ROLLIN RIDGE Filing No. 1 Grading & Erosion Control Plans El Paso County, Colorado

Remove Filing 1 and replace with
Pre-Development Grading & Erosion Control
Plans.

ROLLIN RIDGE ESTATES - FILING NO. 1

**GEC PLAN
TITLE SHEET**

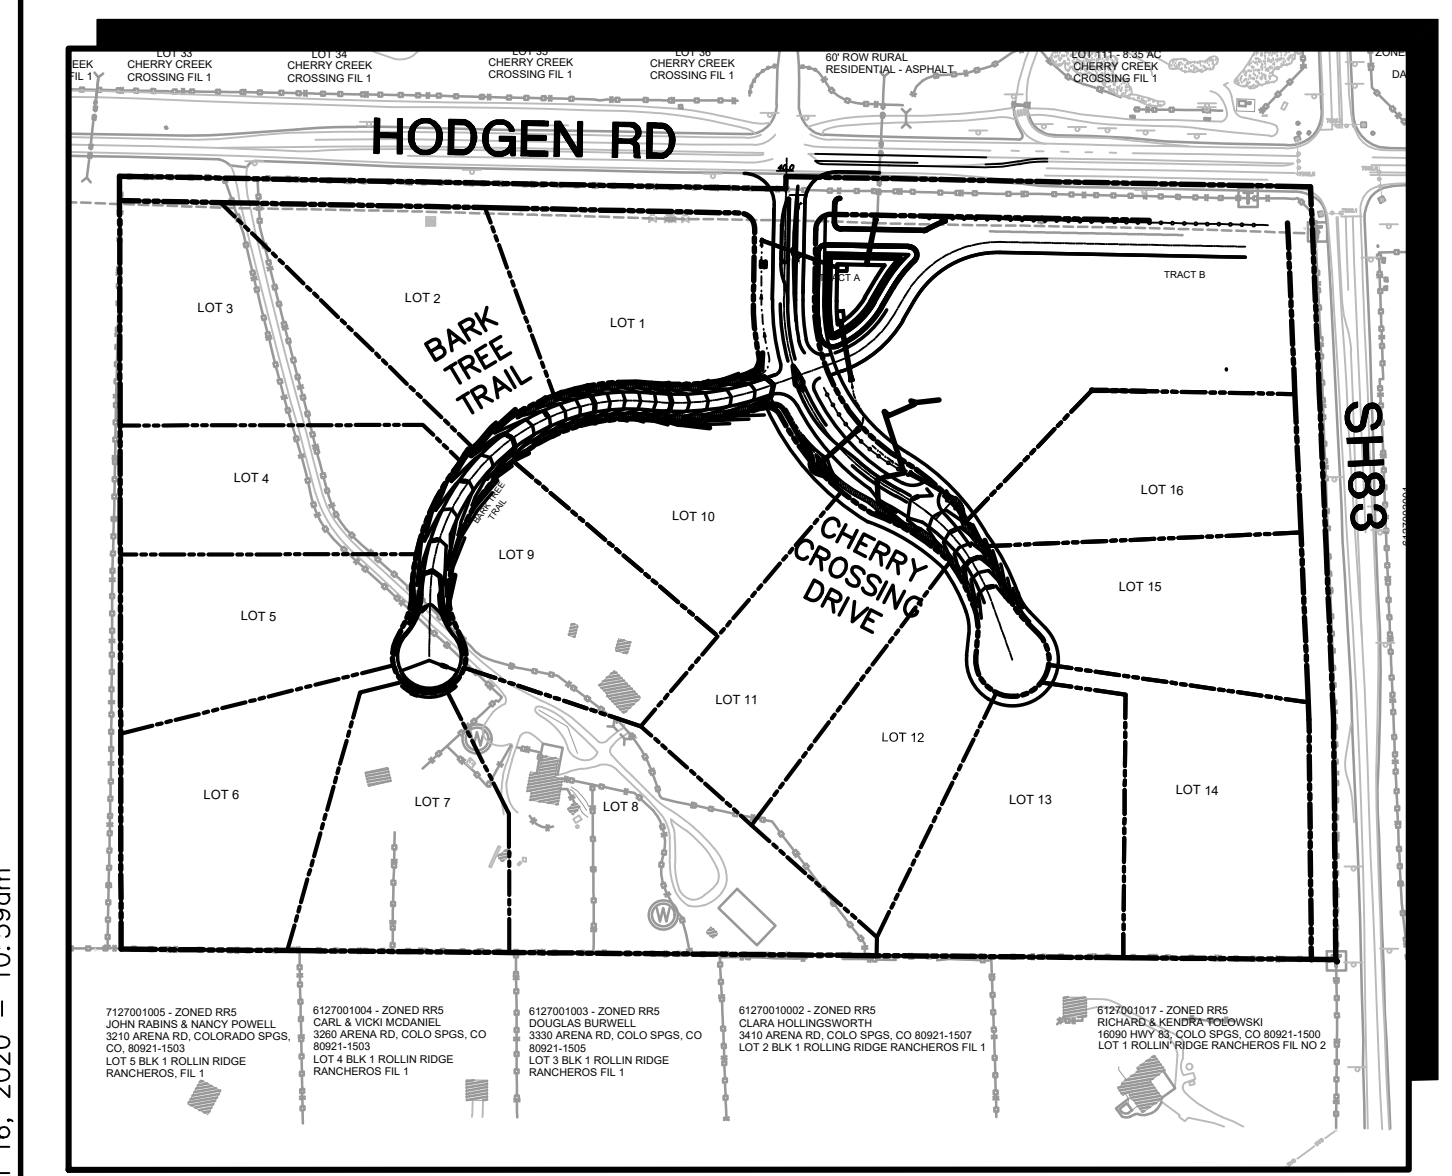
Remove delta revisions.

GENERAL NOTES & LEGEND

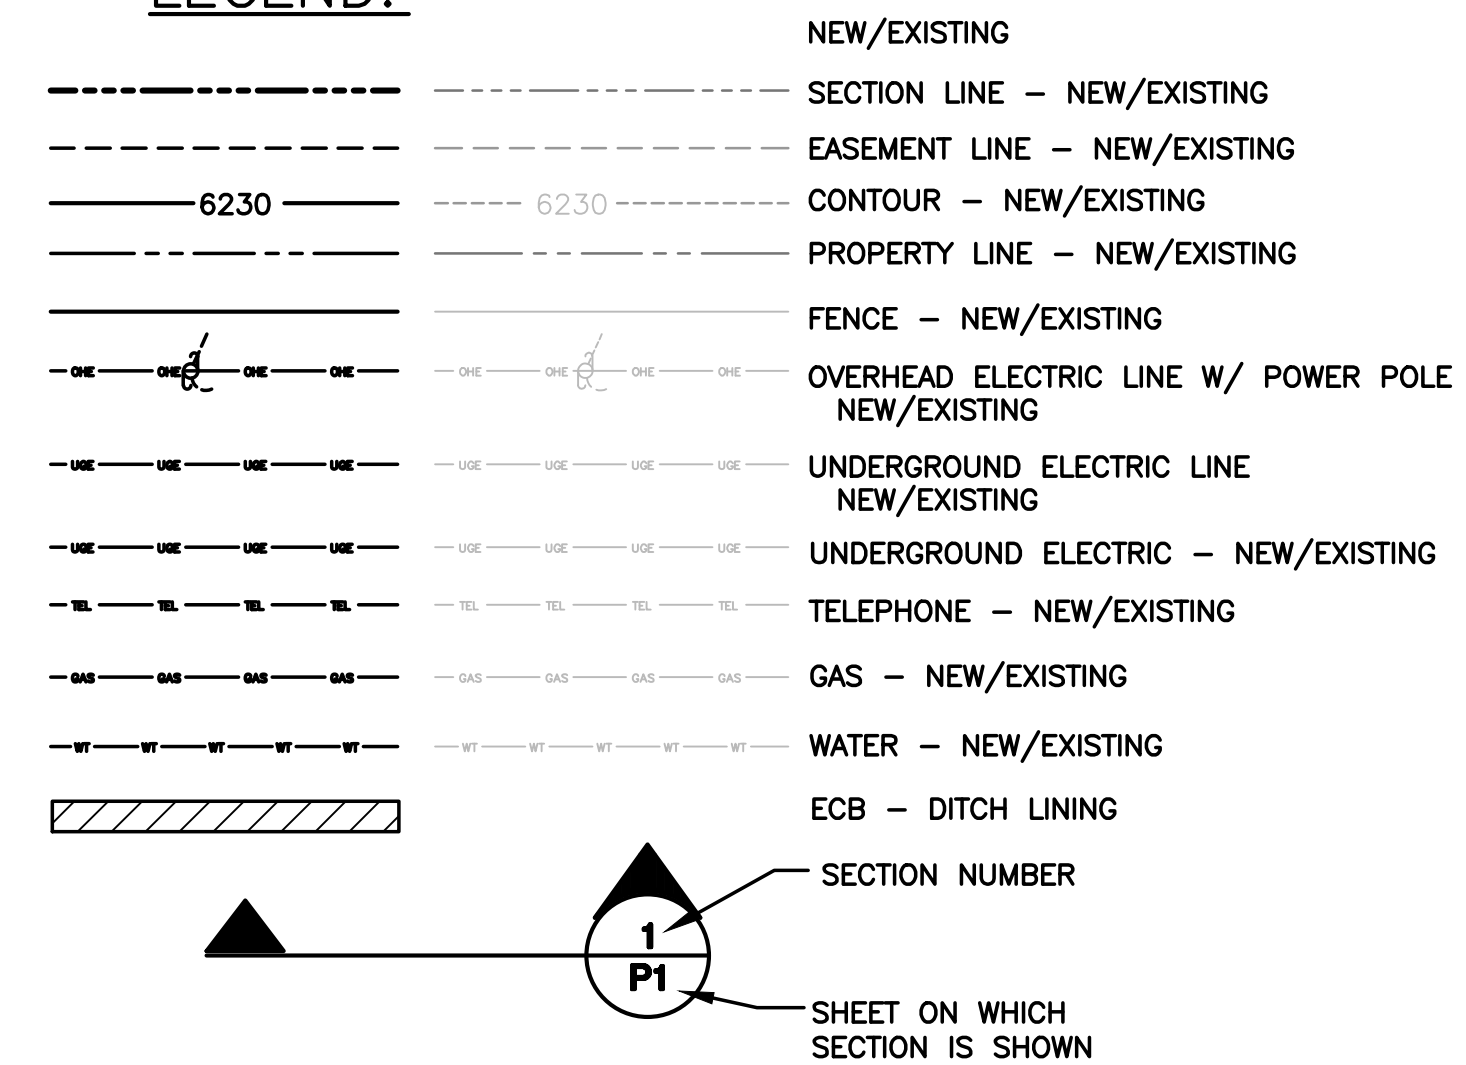
Item I - Discuss existing vegetation

SITE GRADING & EROSION CONTROL PLAN

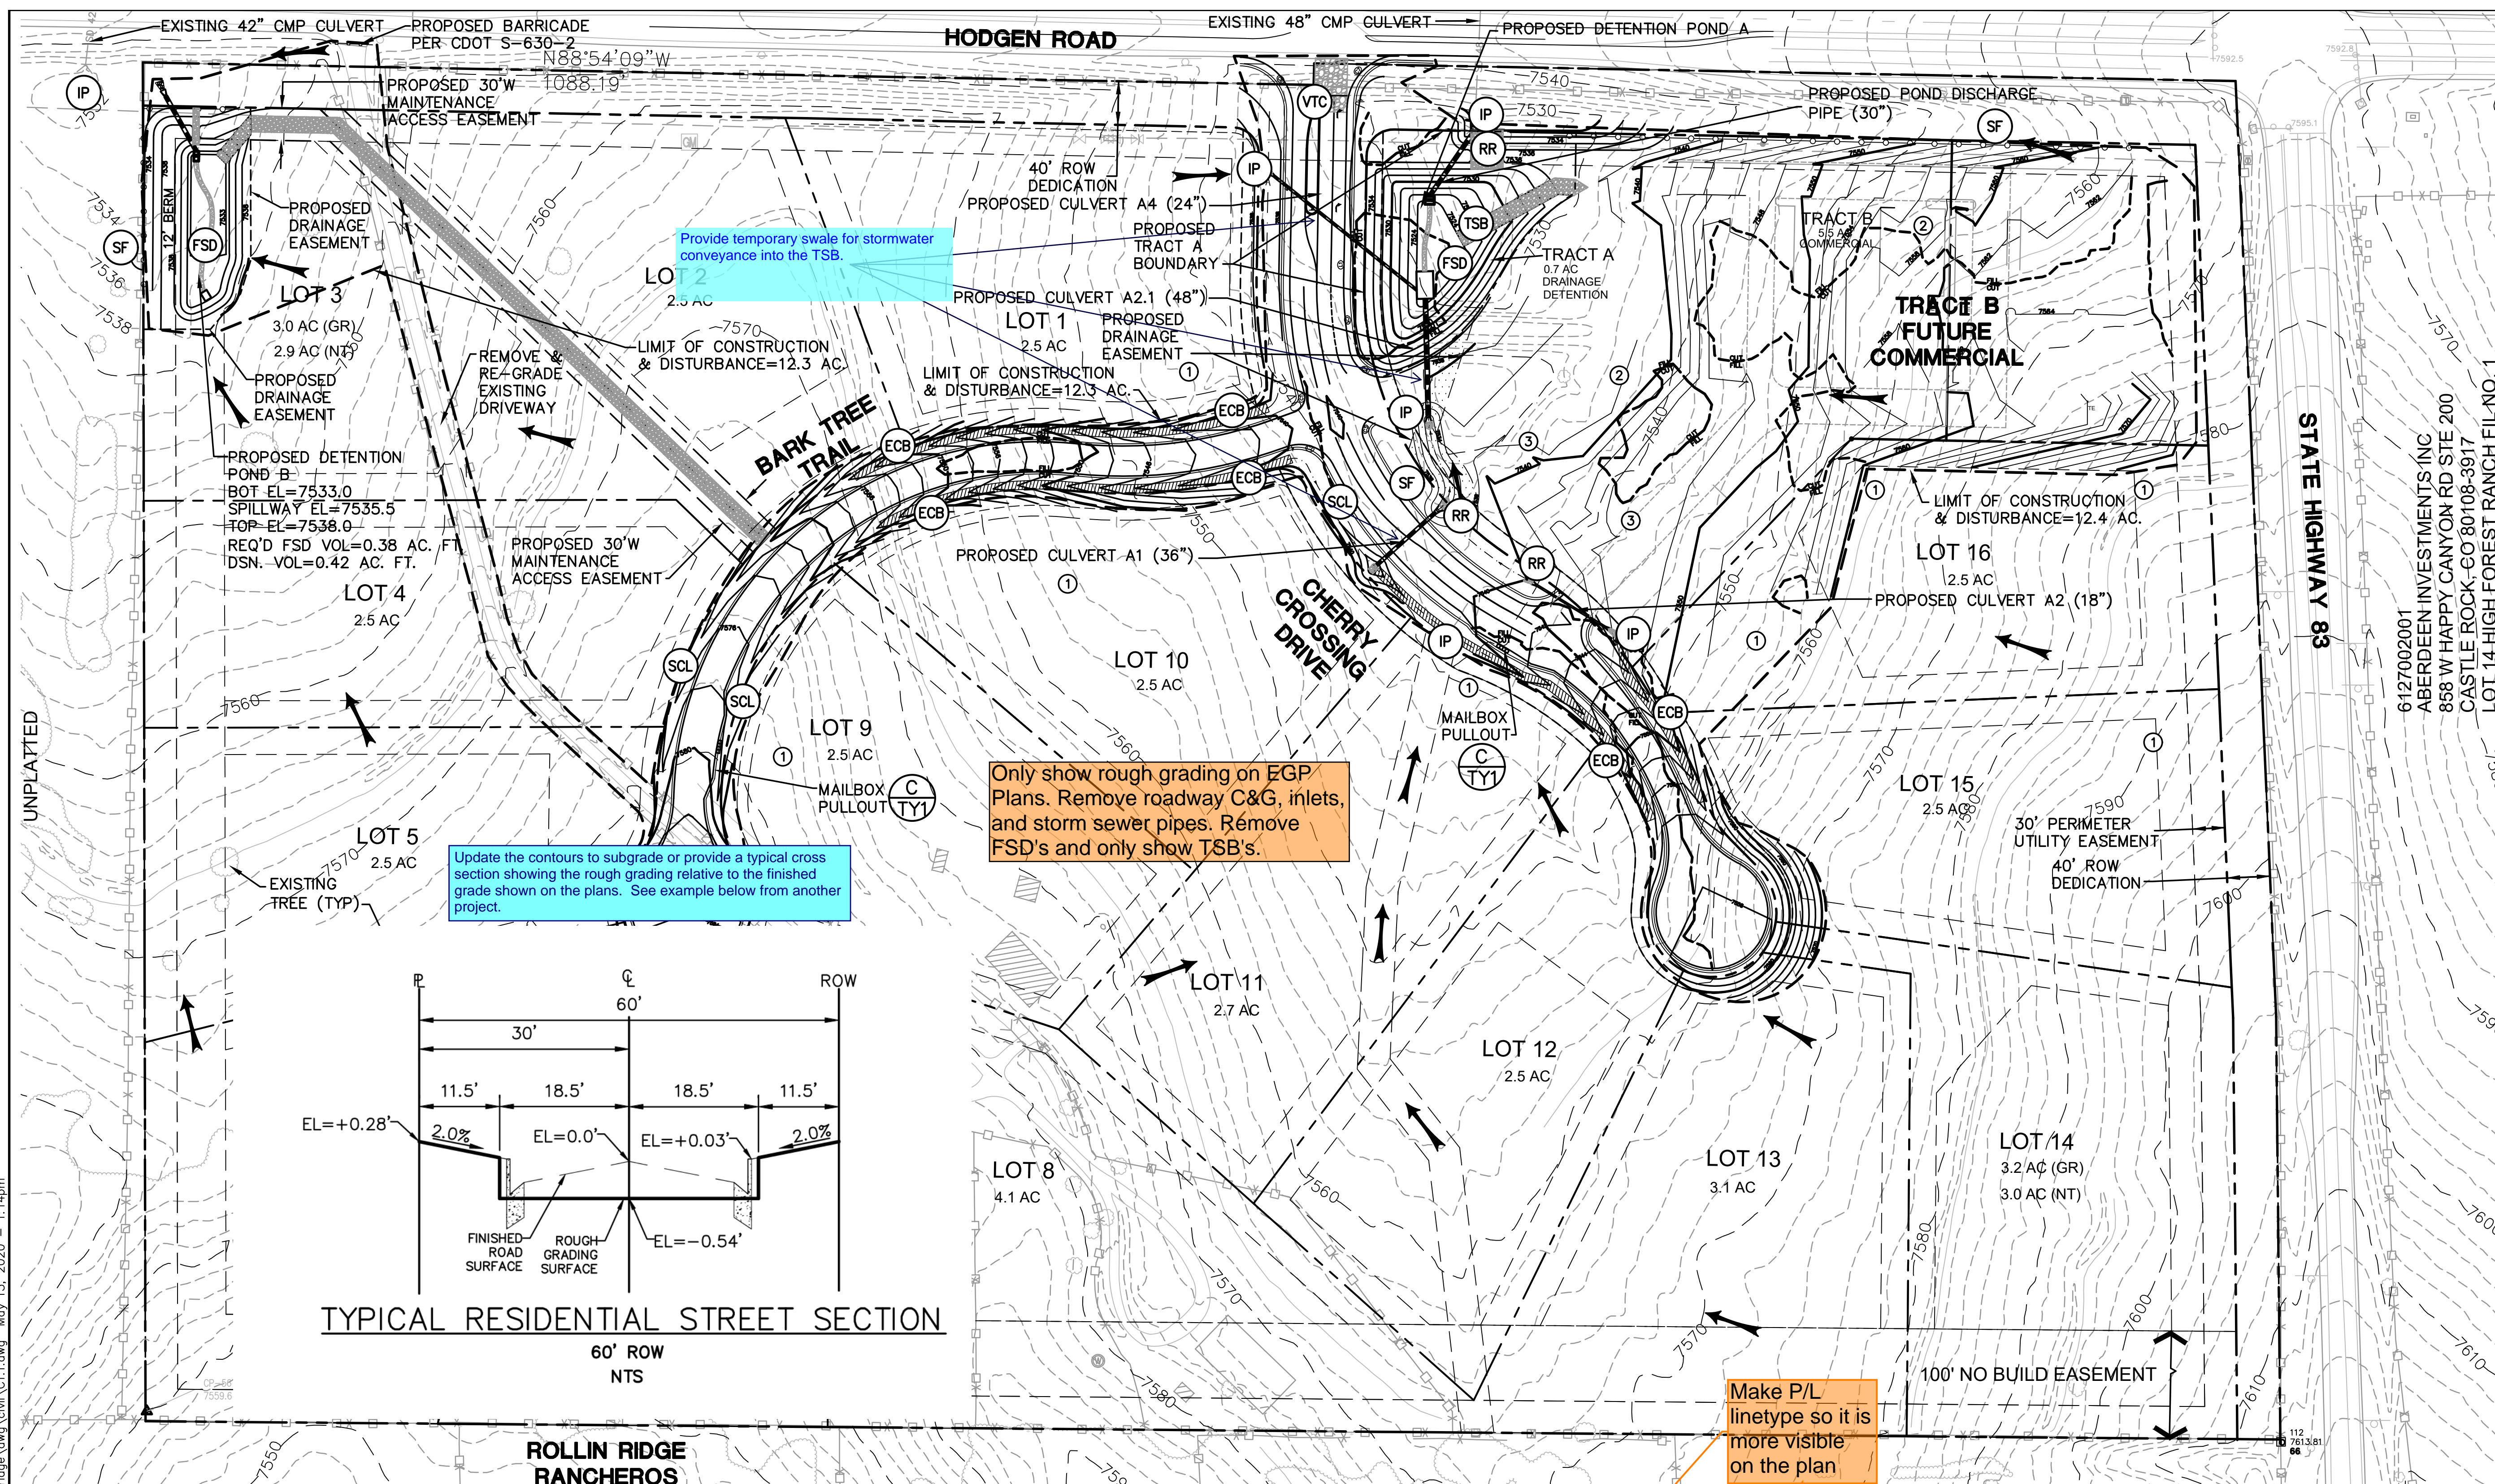
Show approx limits of these areas with appropriate control measures (like perimeter silt fence).

Include the following items in Legend:
 - cut/fill line
 - Limits of Disturbance / Construction
 - Drainage arrows
 - Concrete washout area

NORTHEAST SITE OVERLOT GRADING PLAN

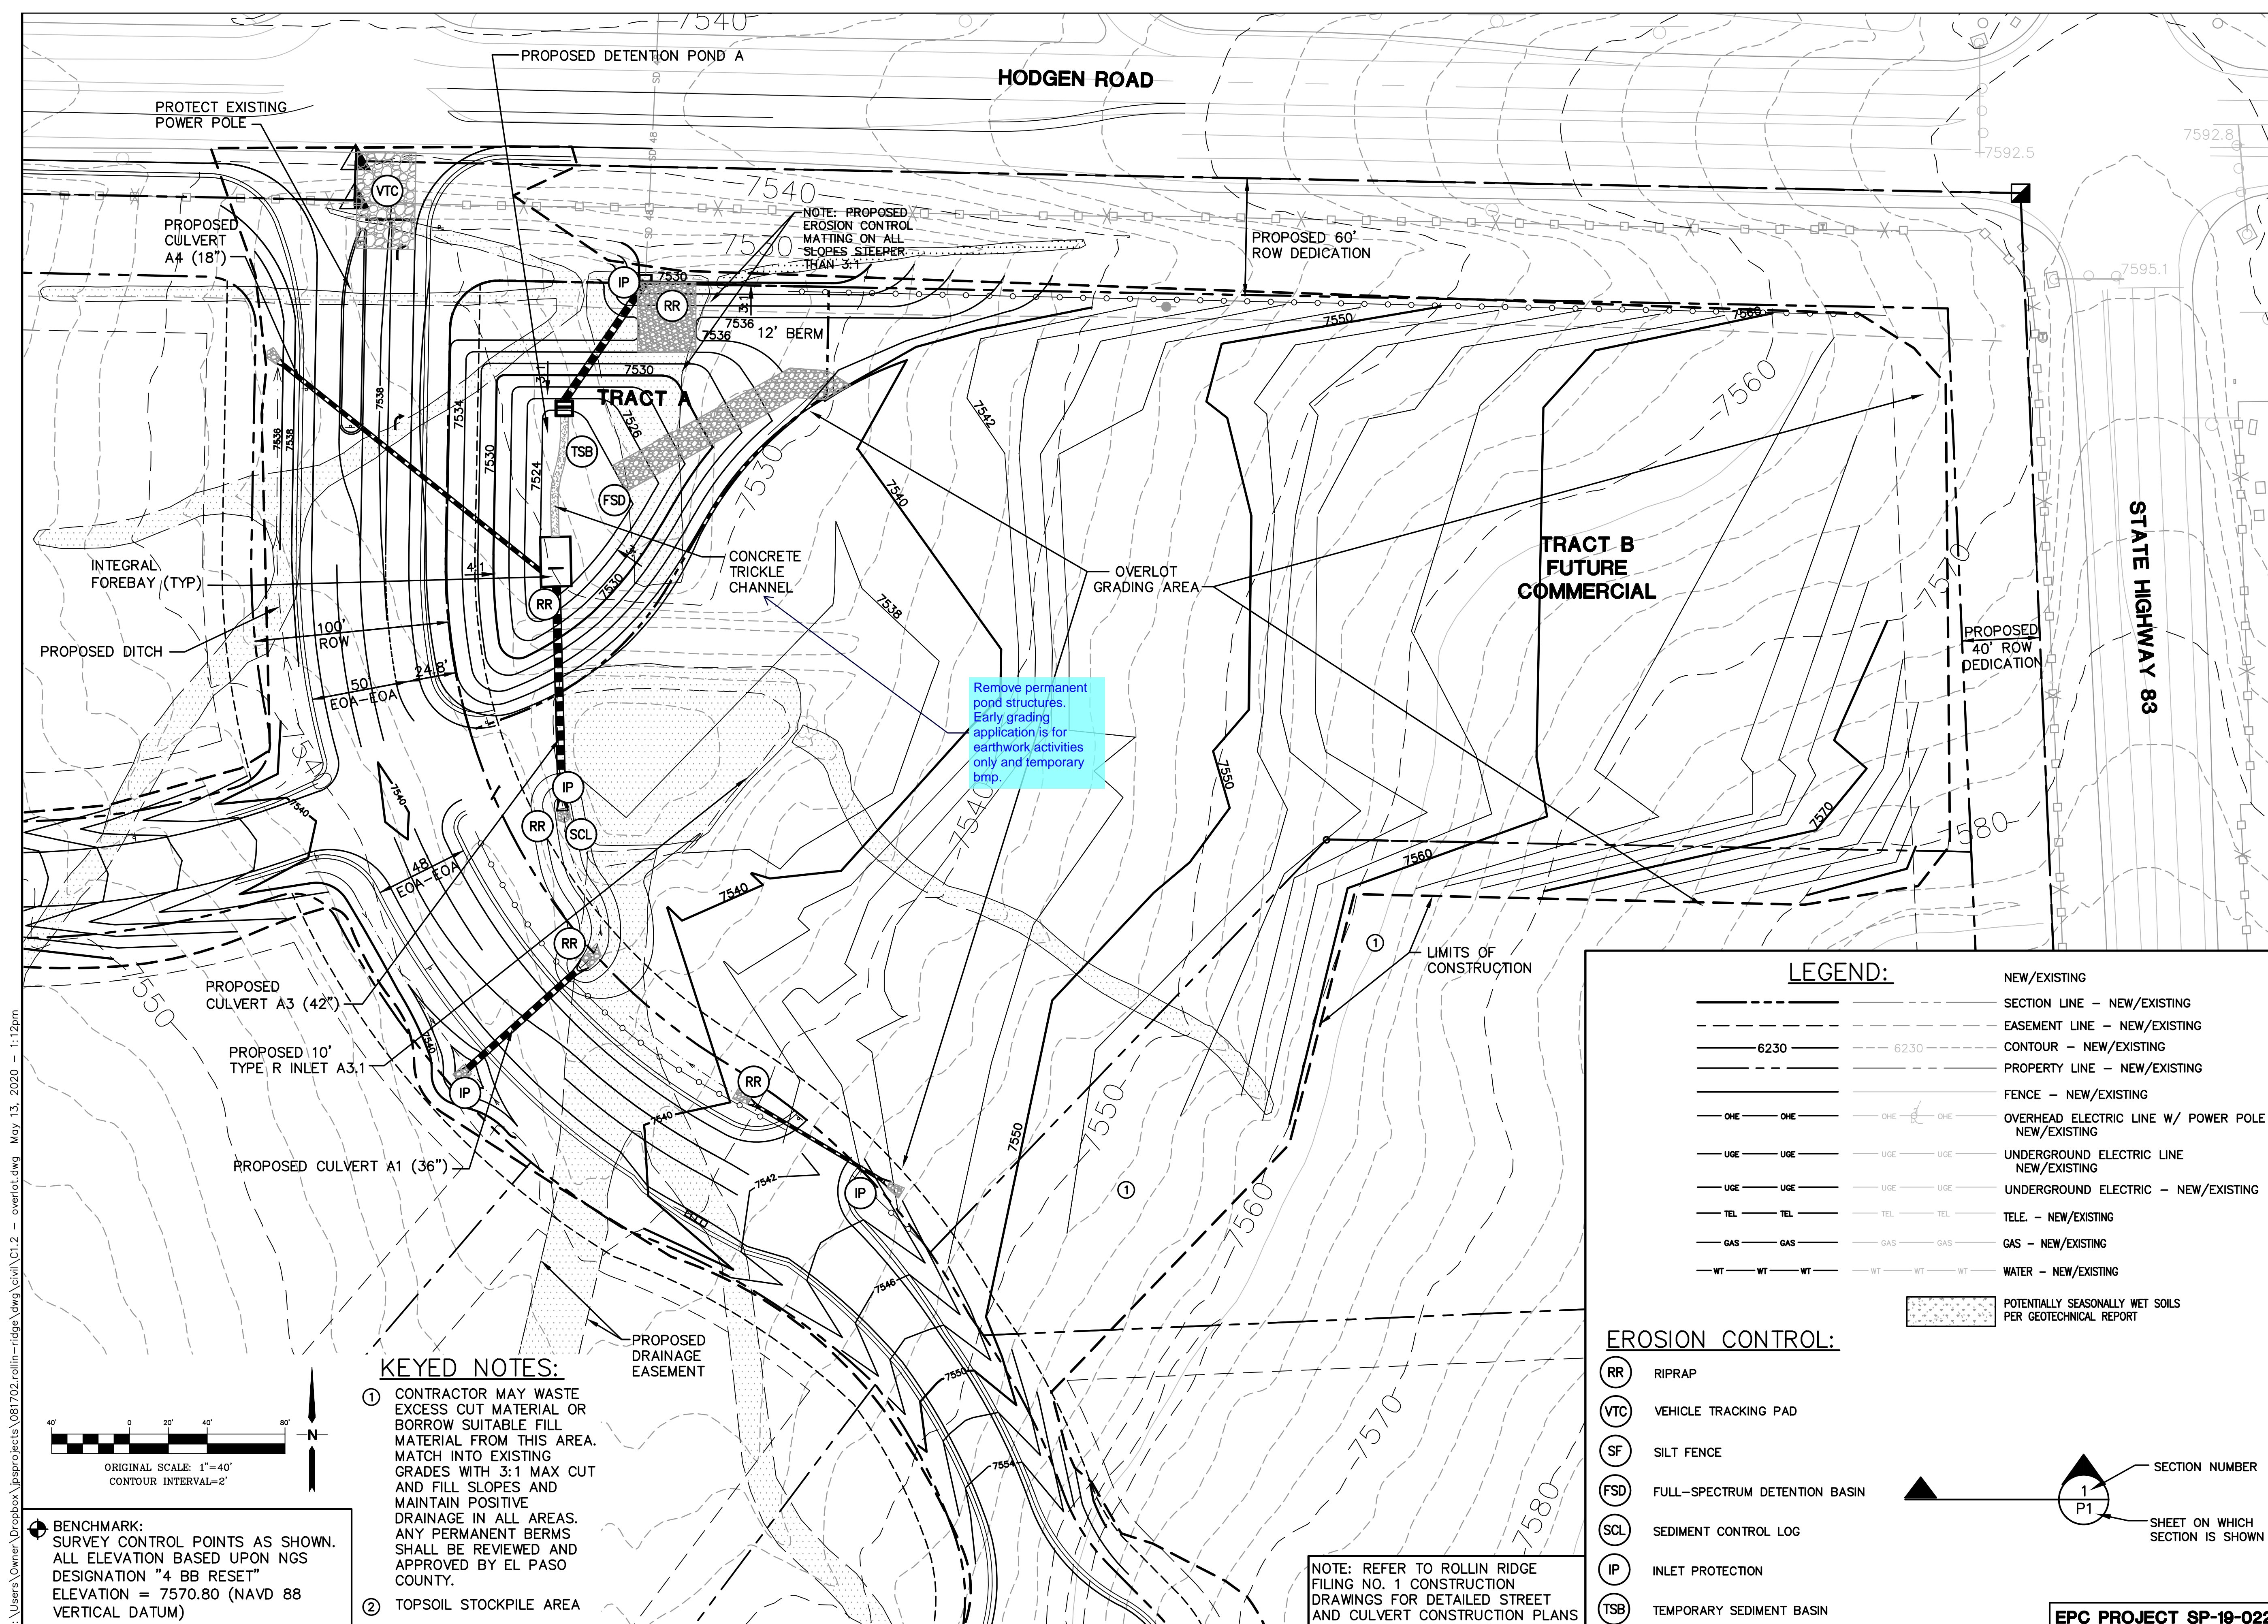
Remove permanent pond structures. Early grading application is for earthwork activities only and temporary bmp.
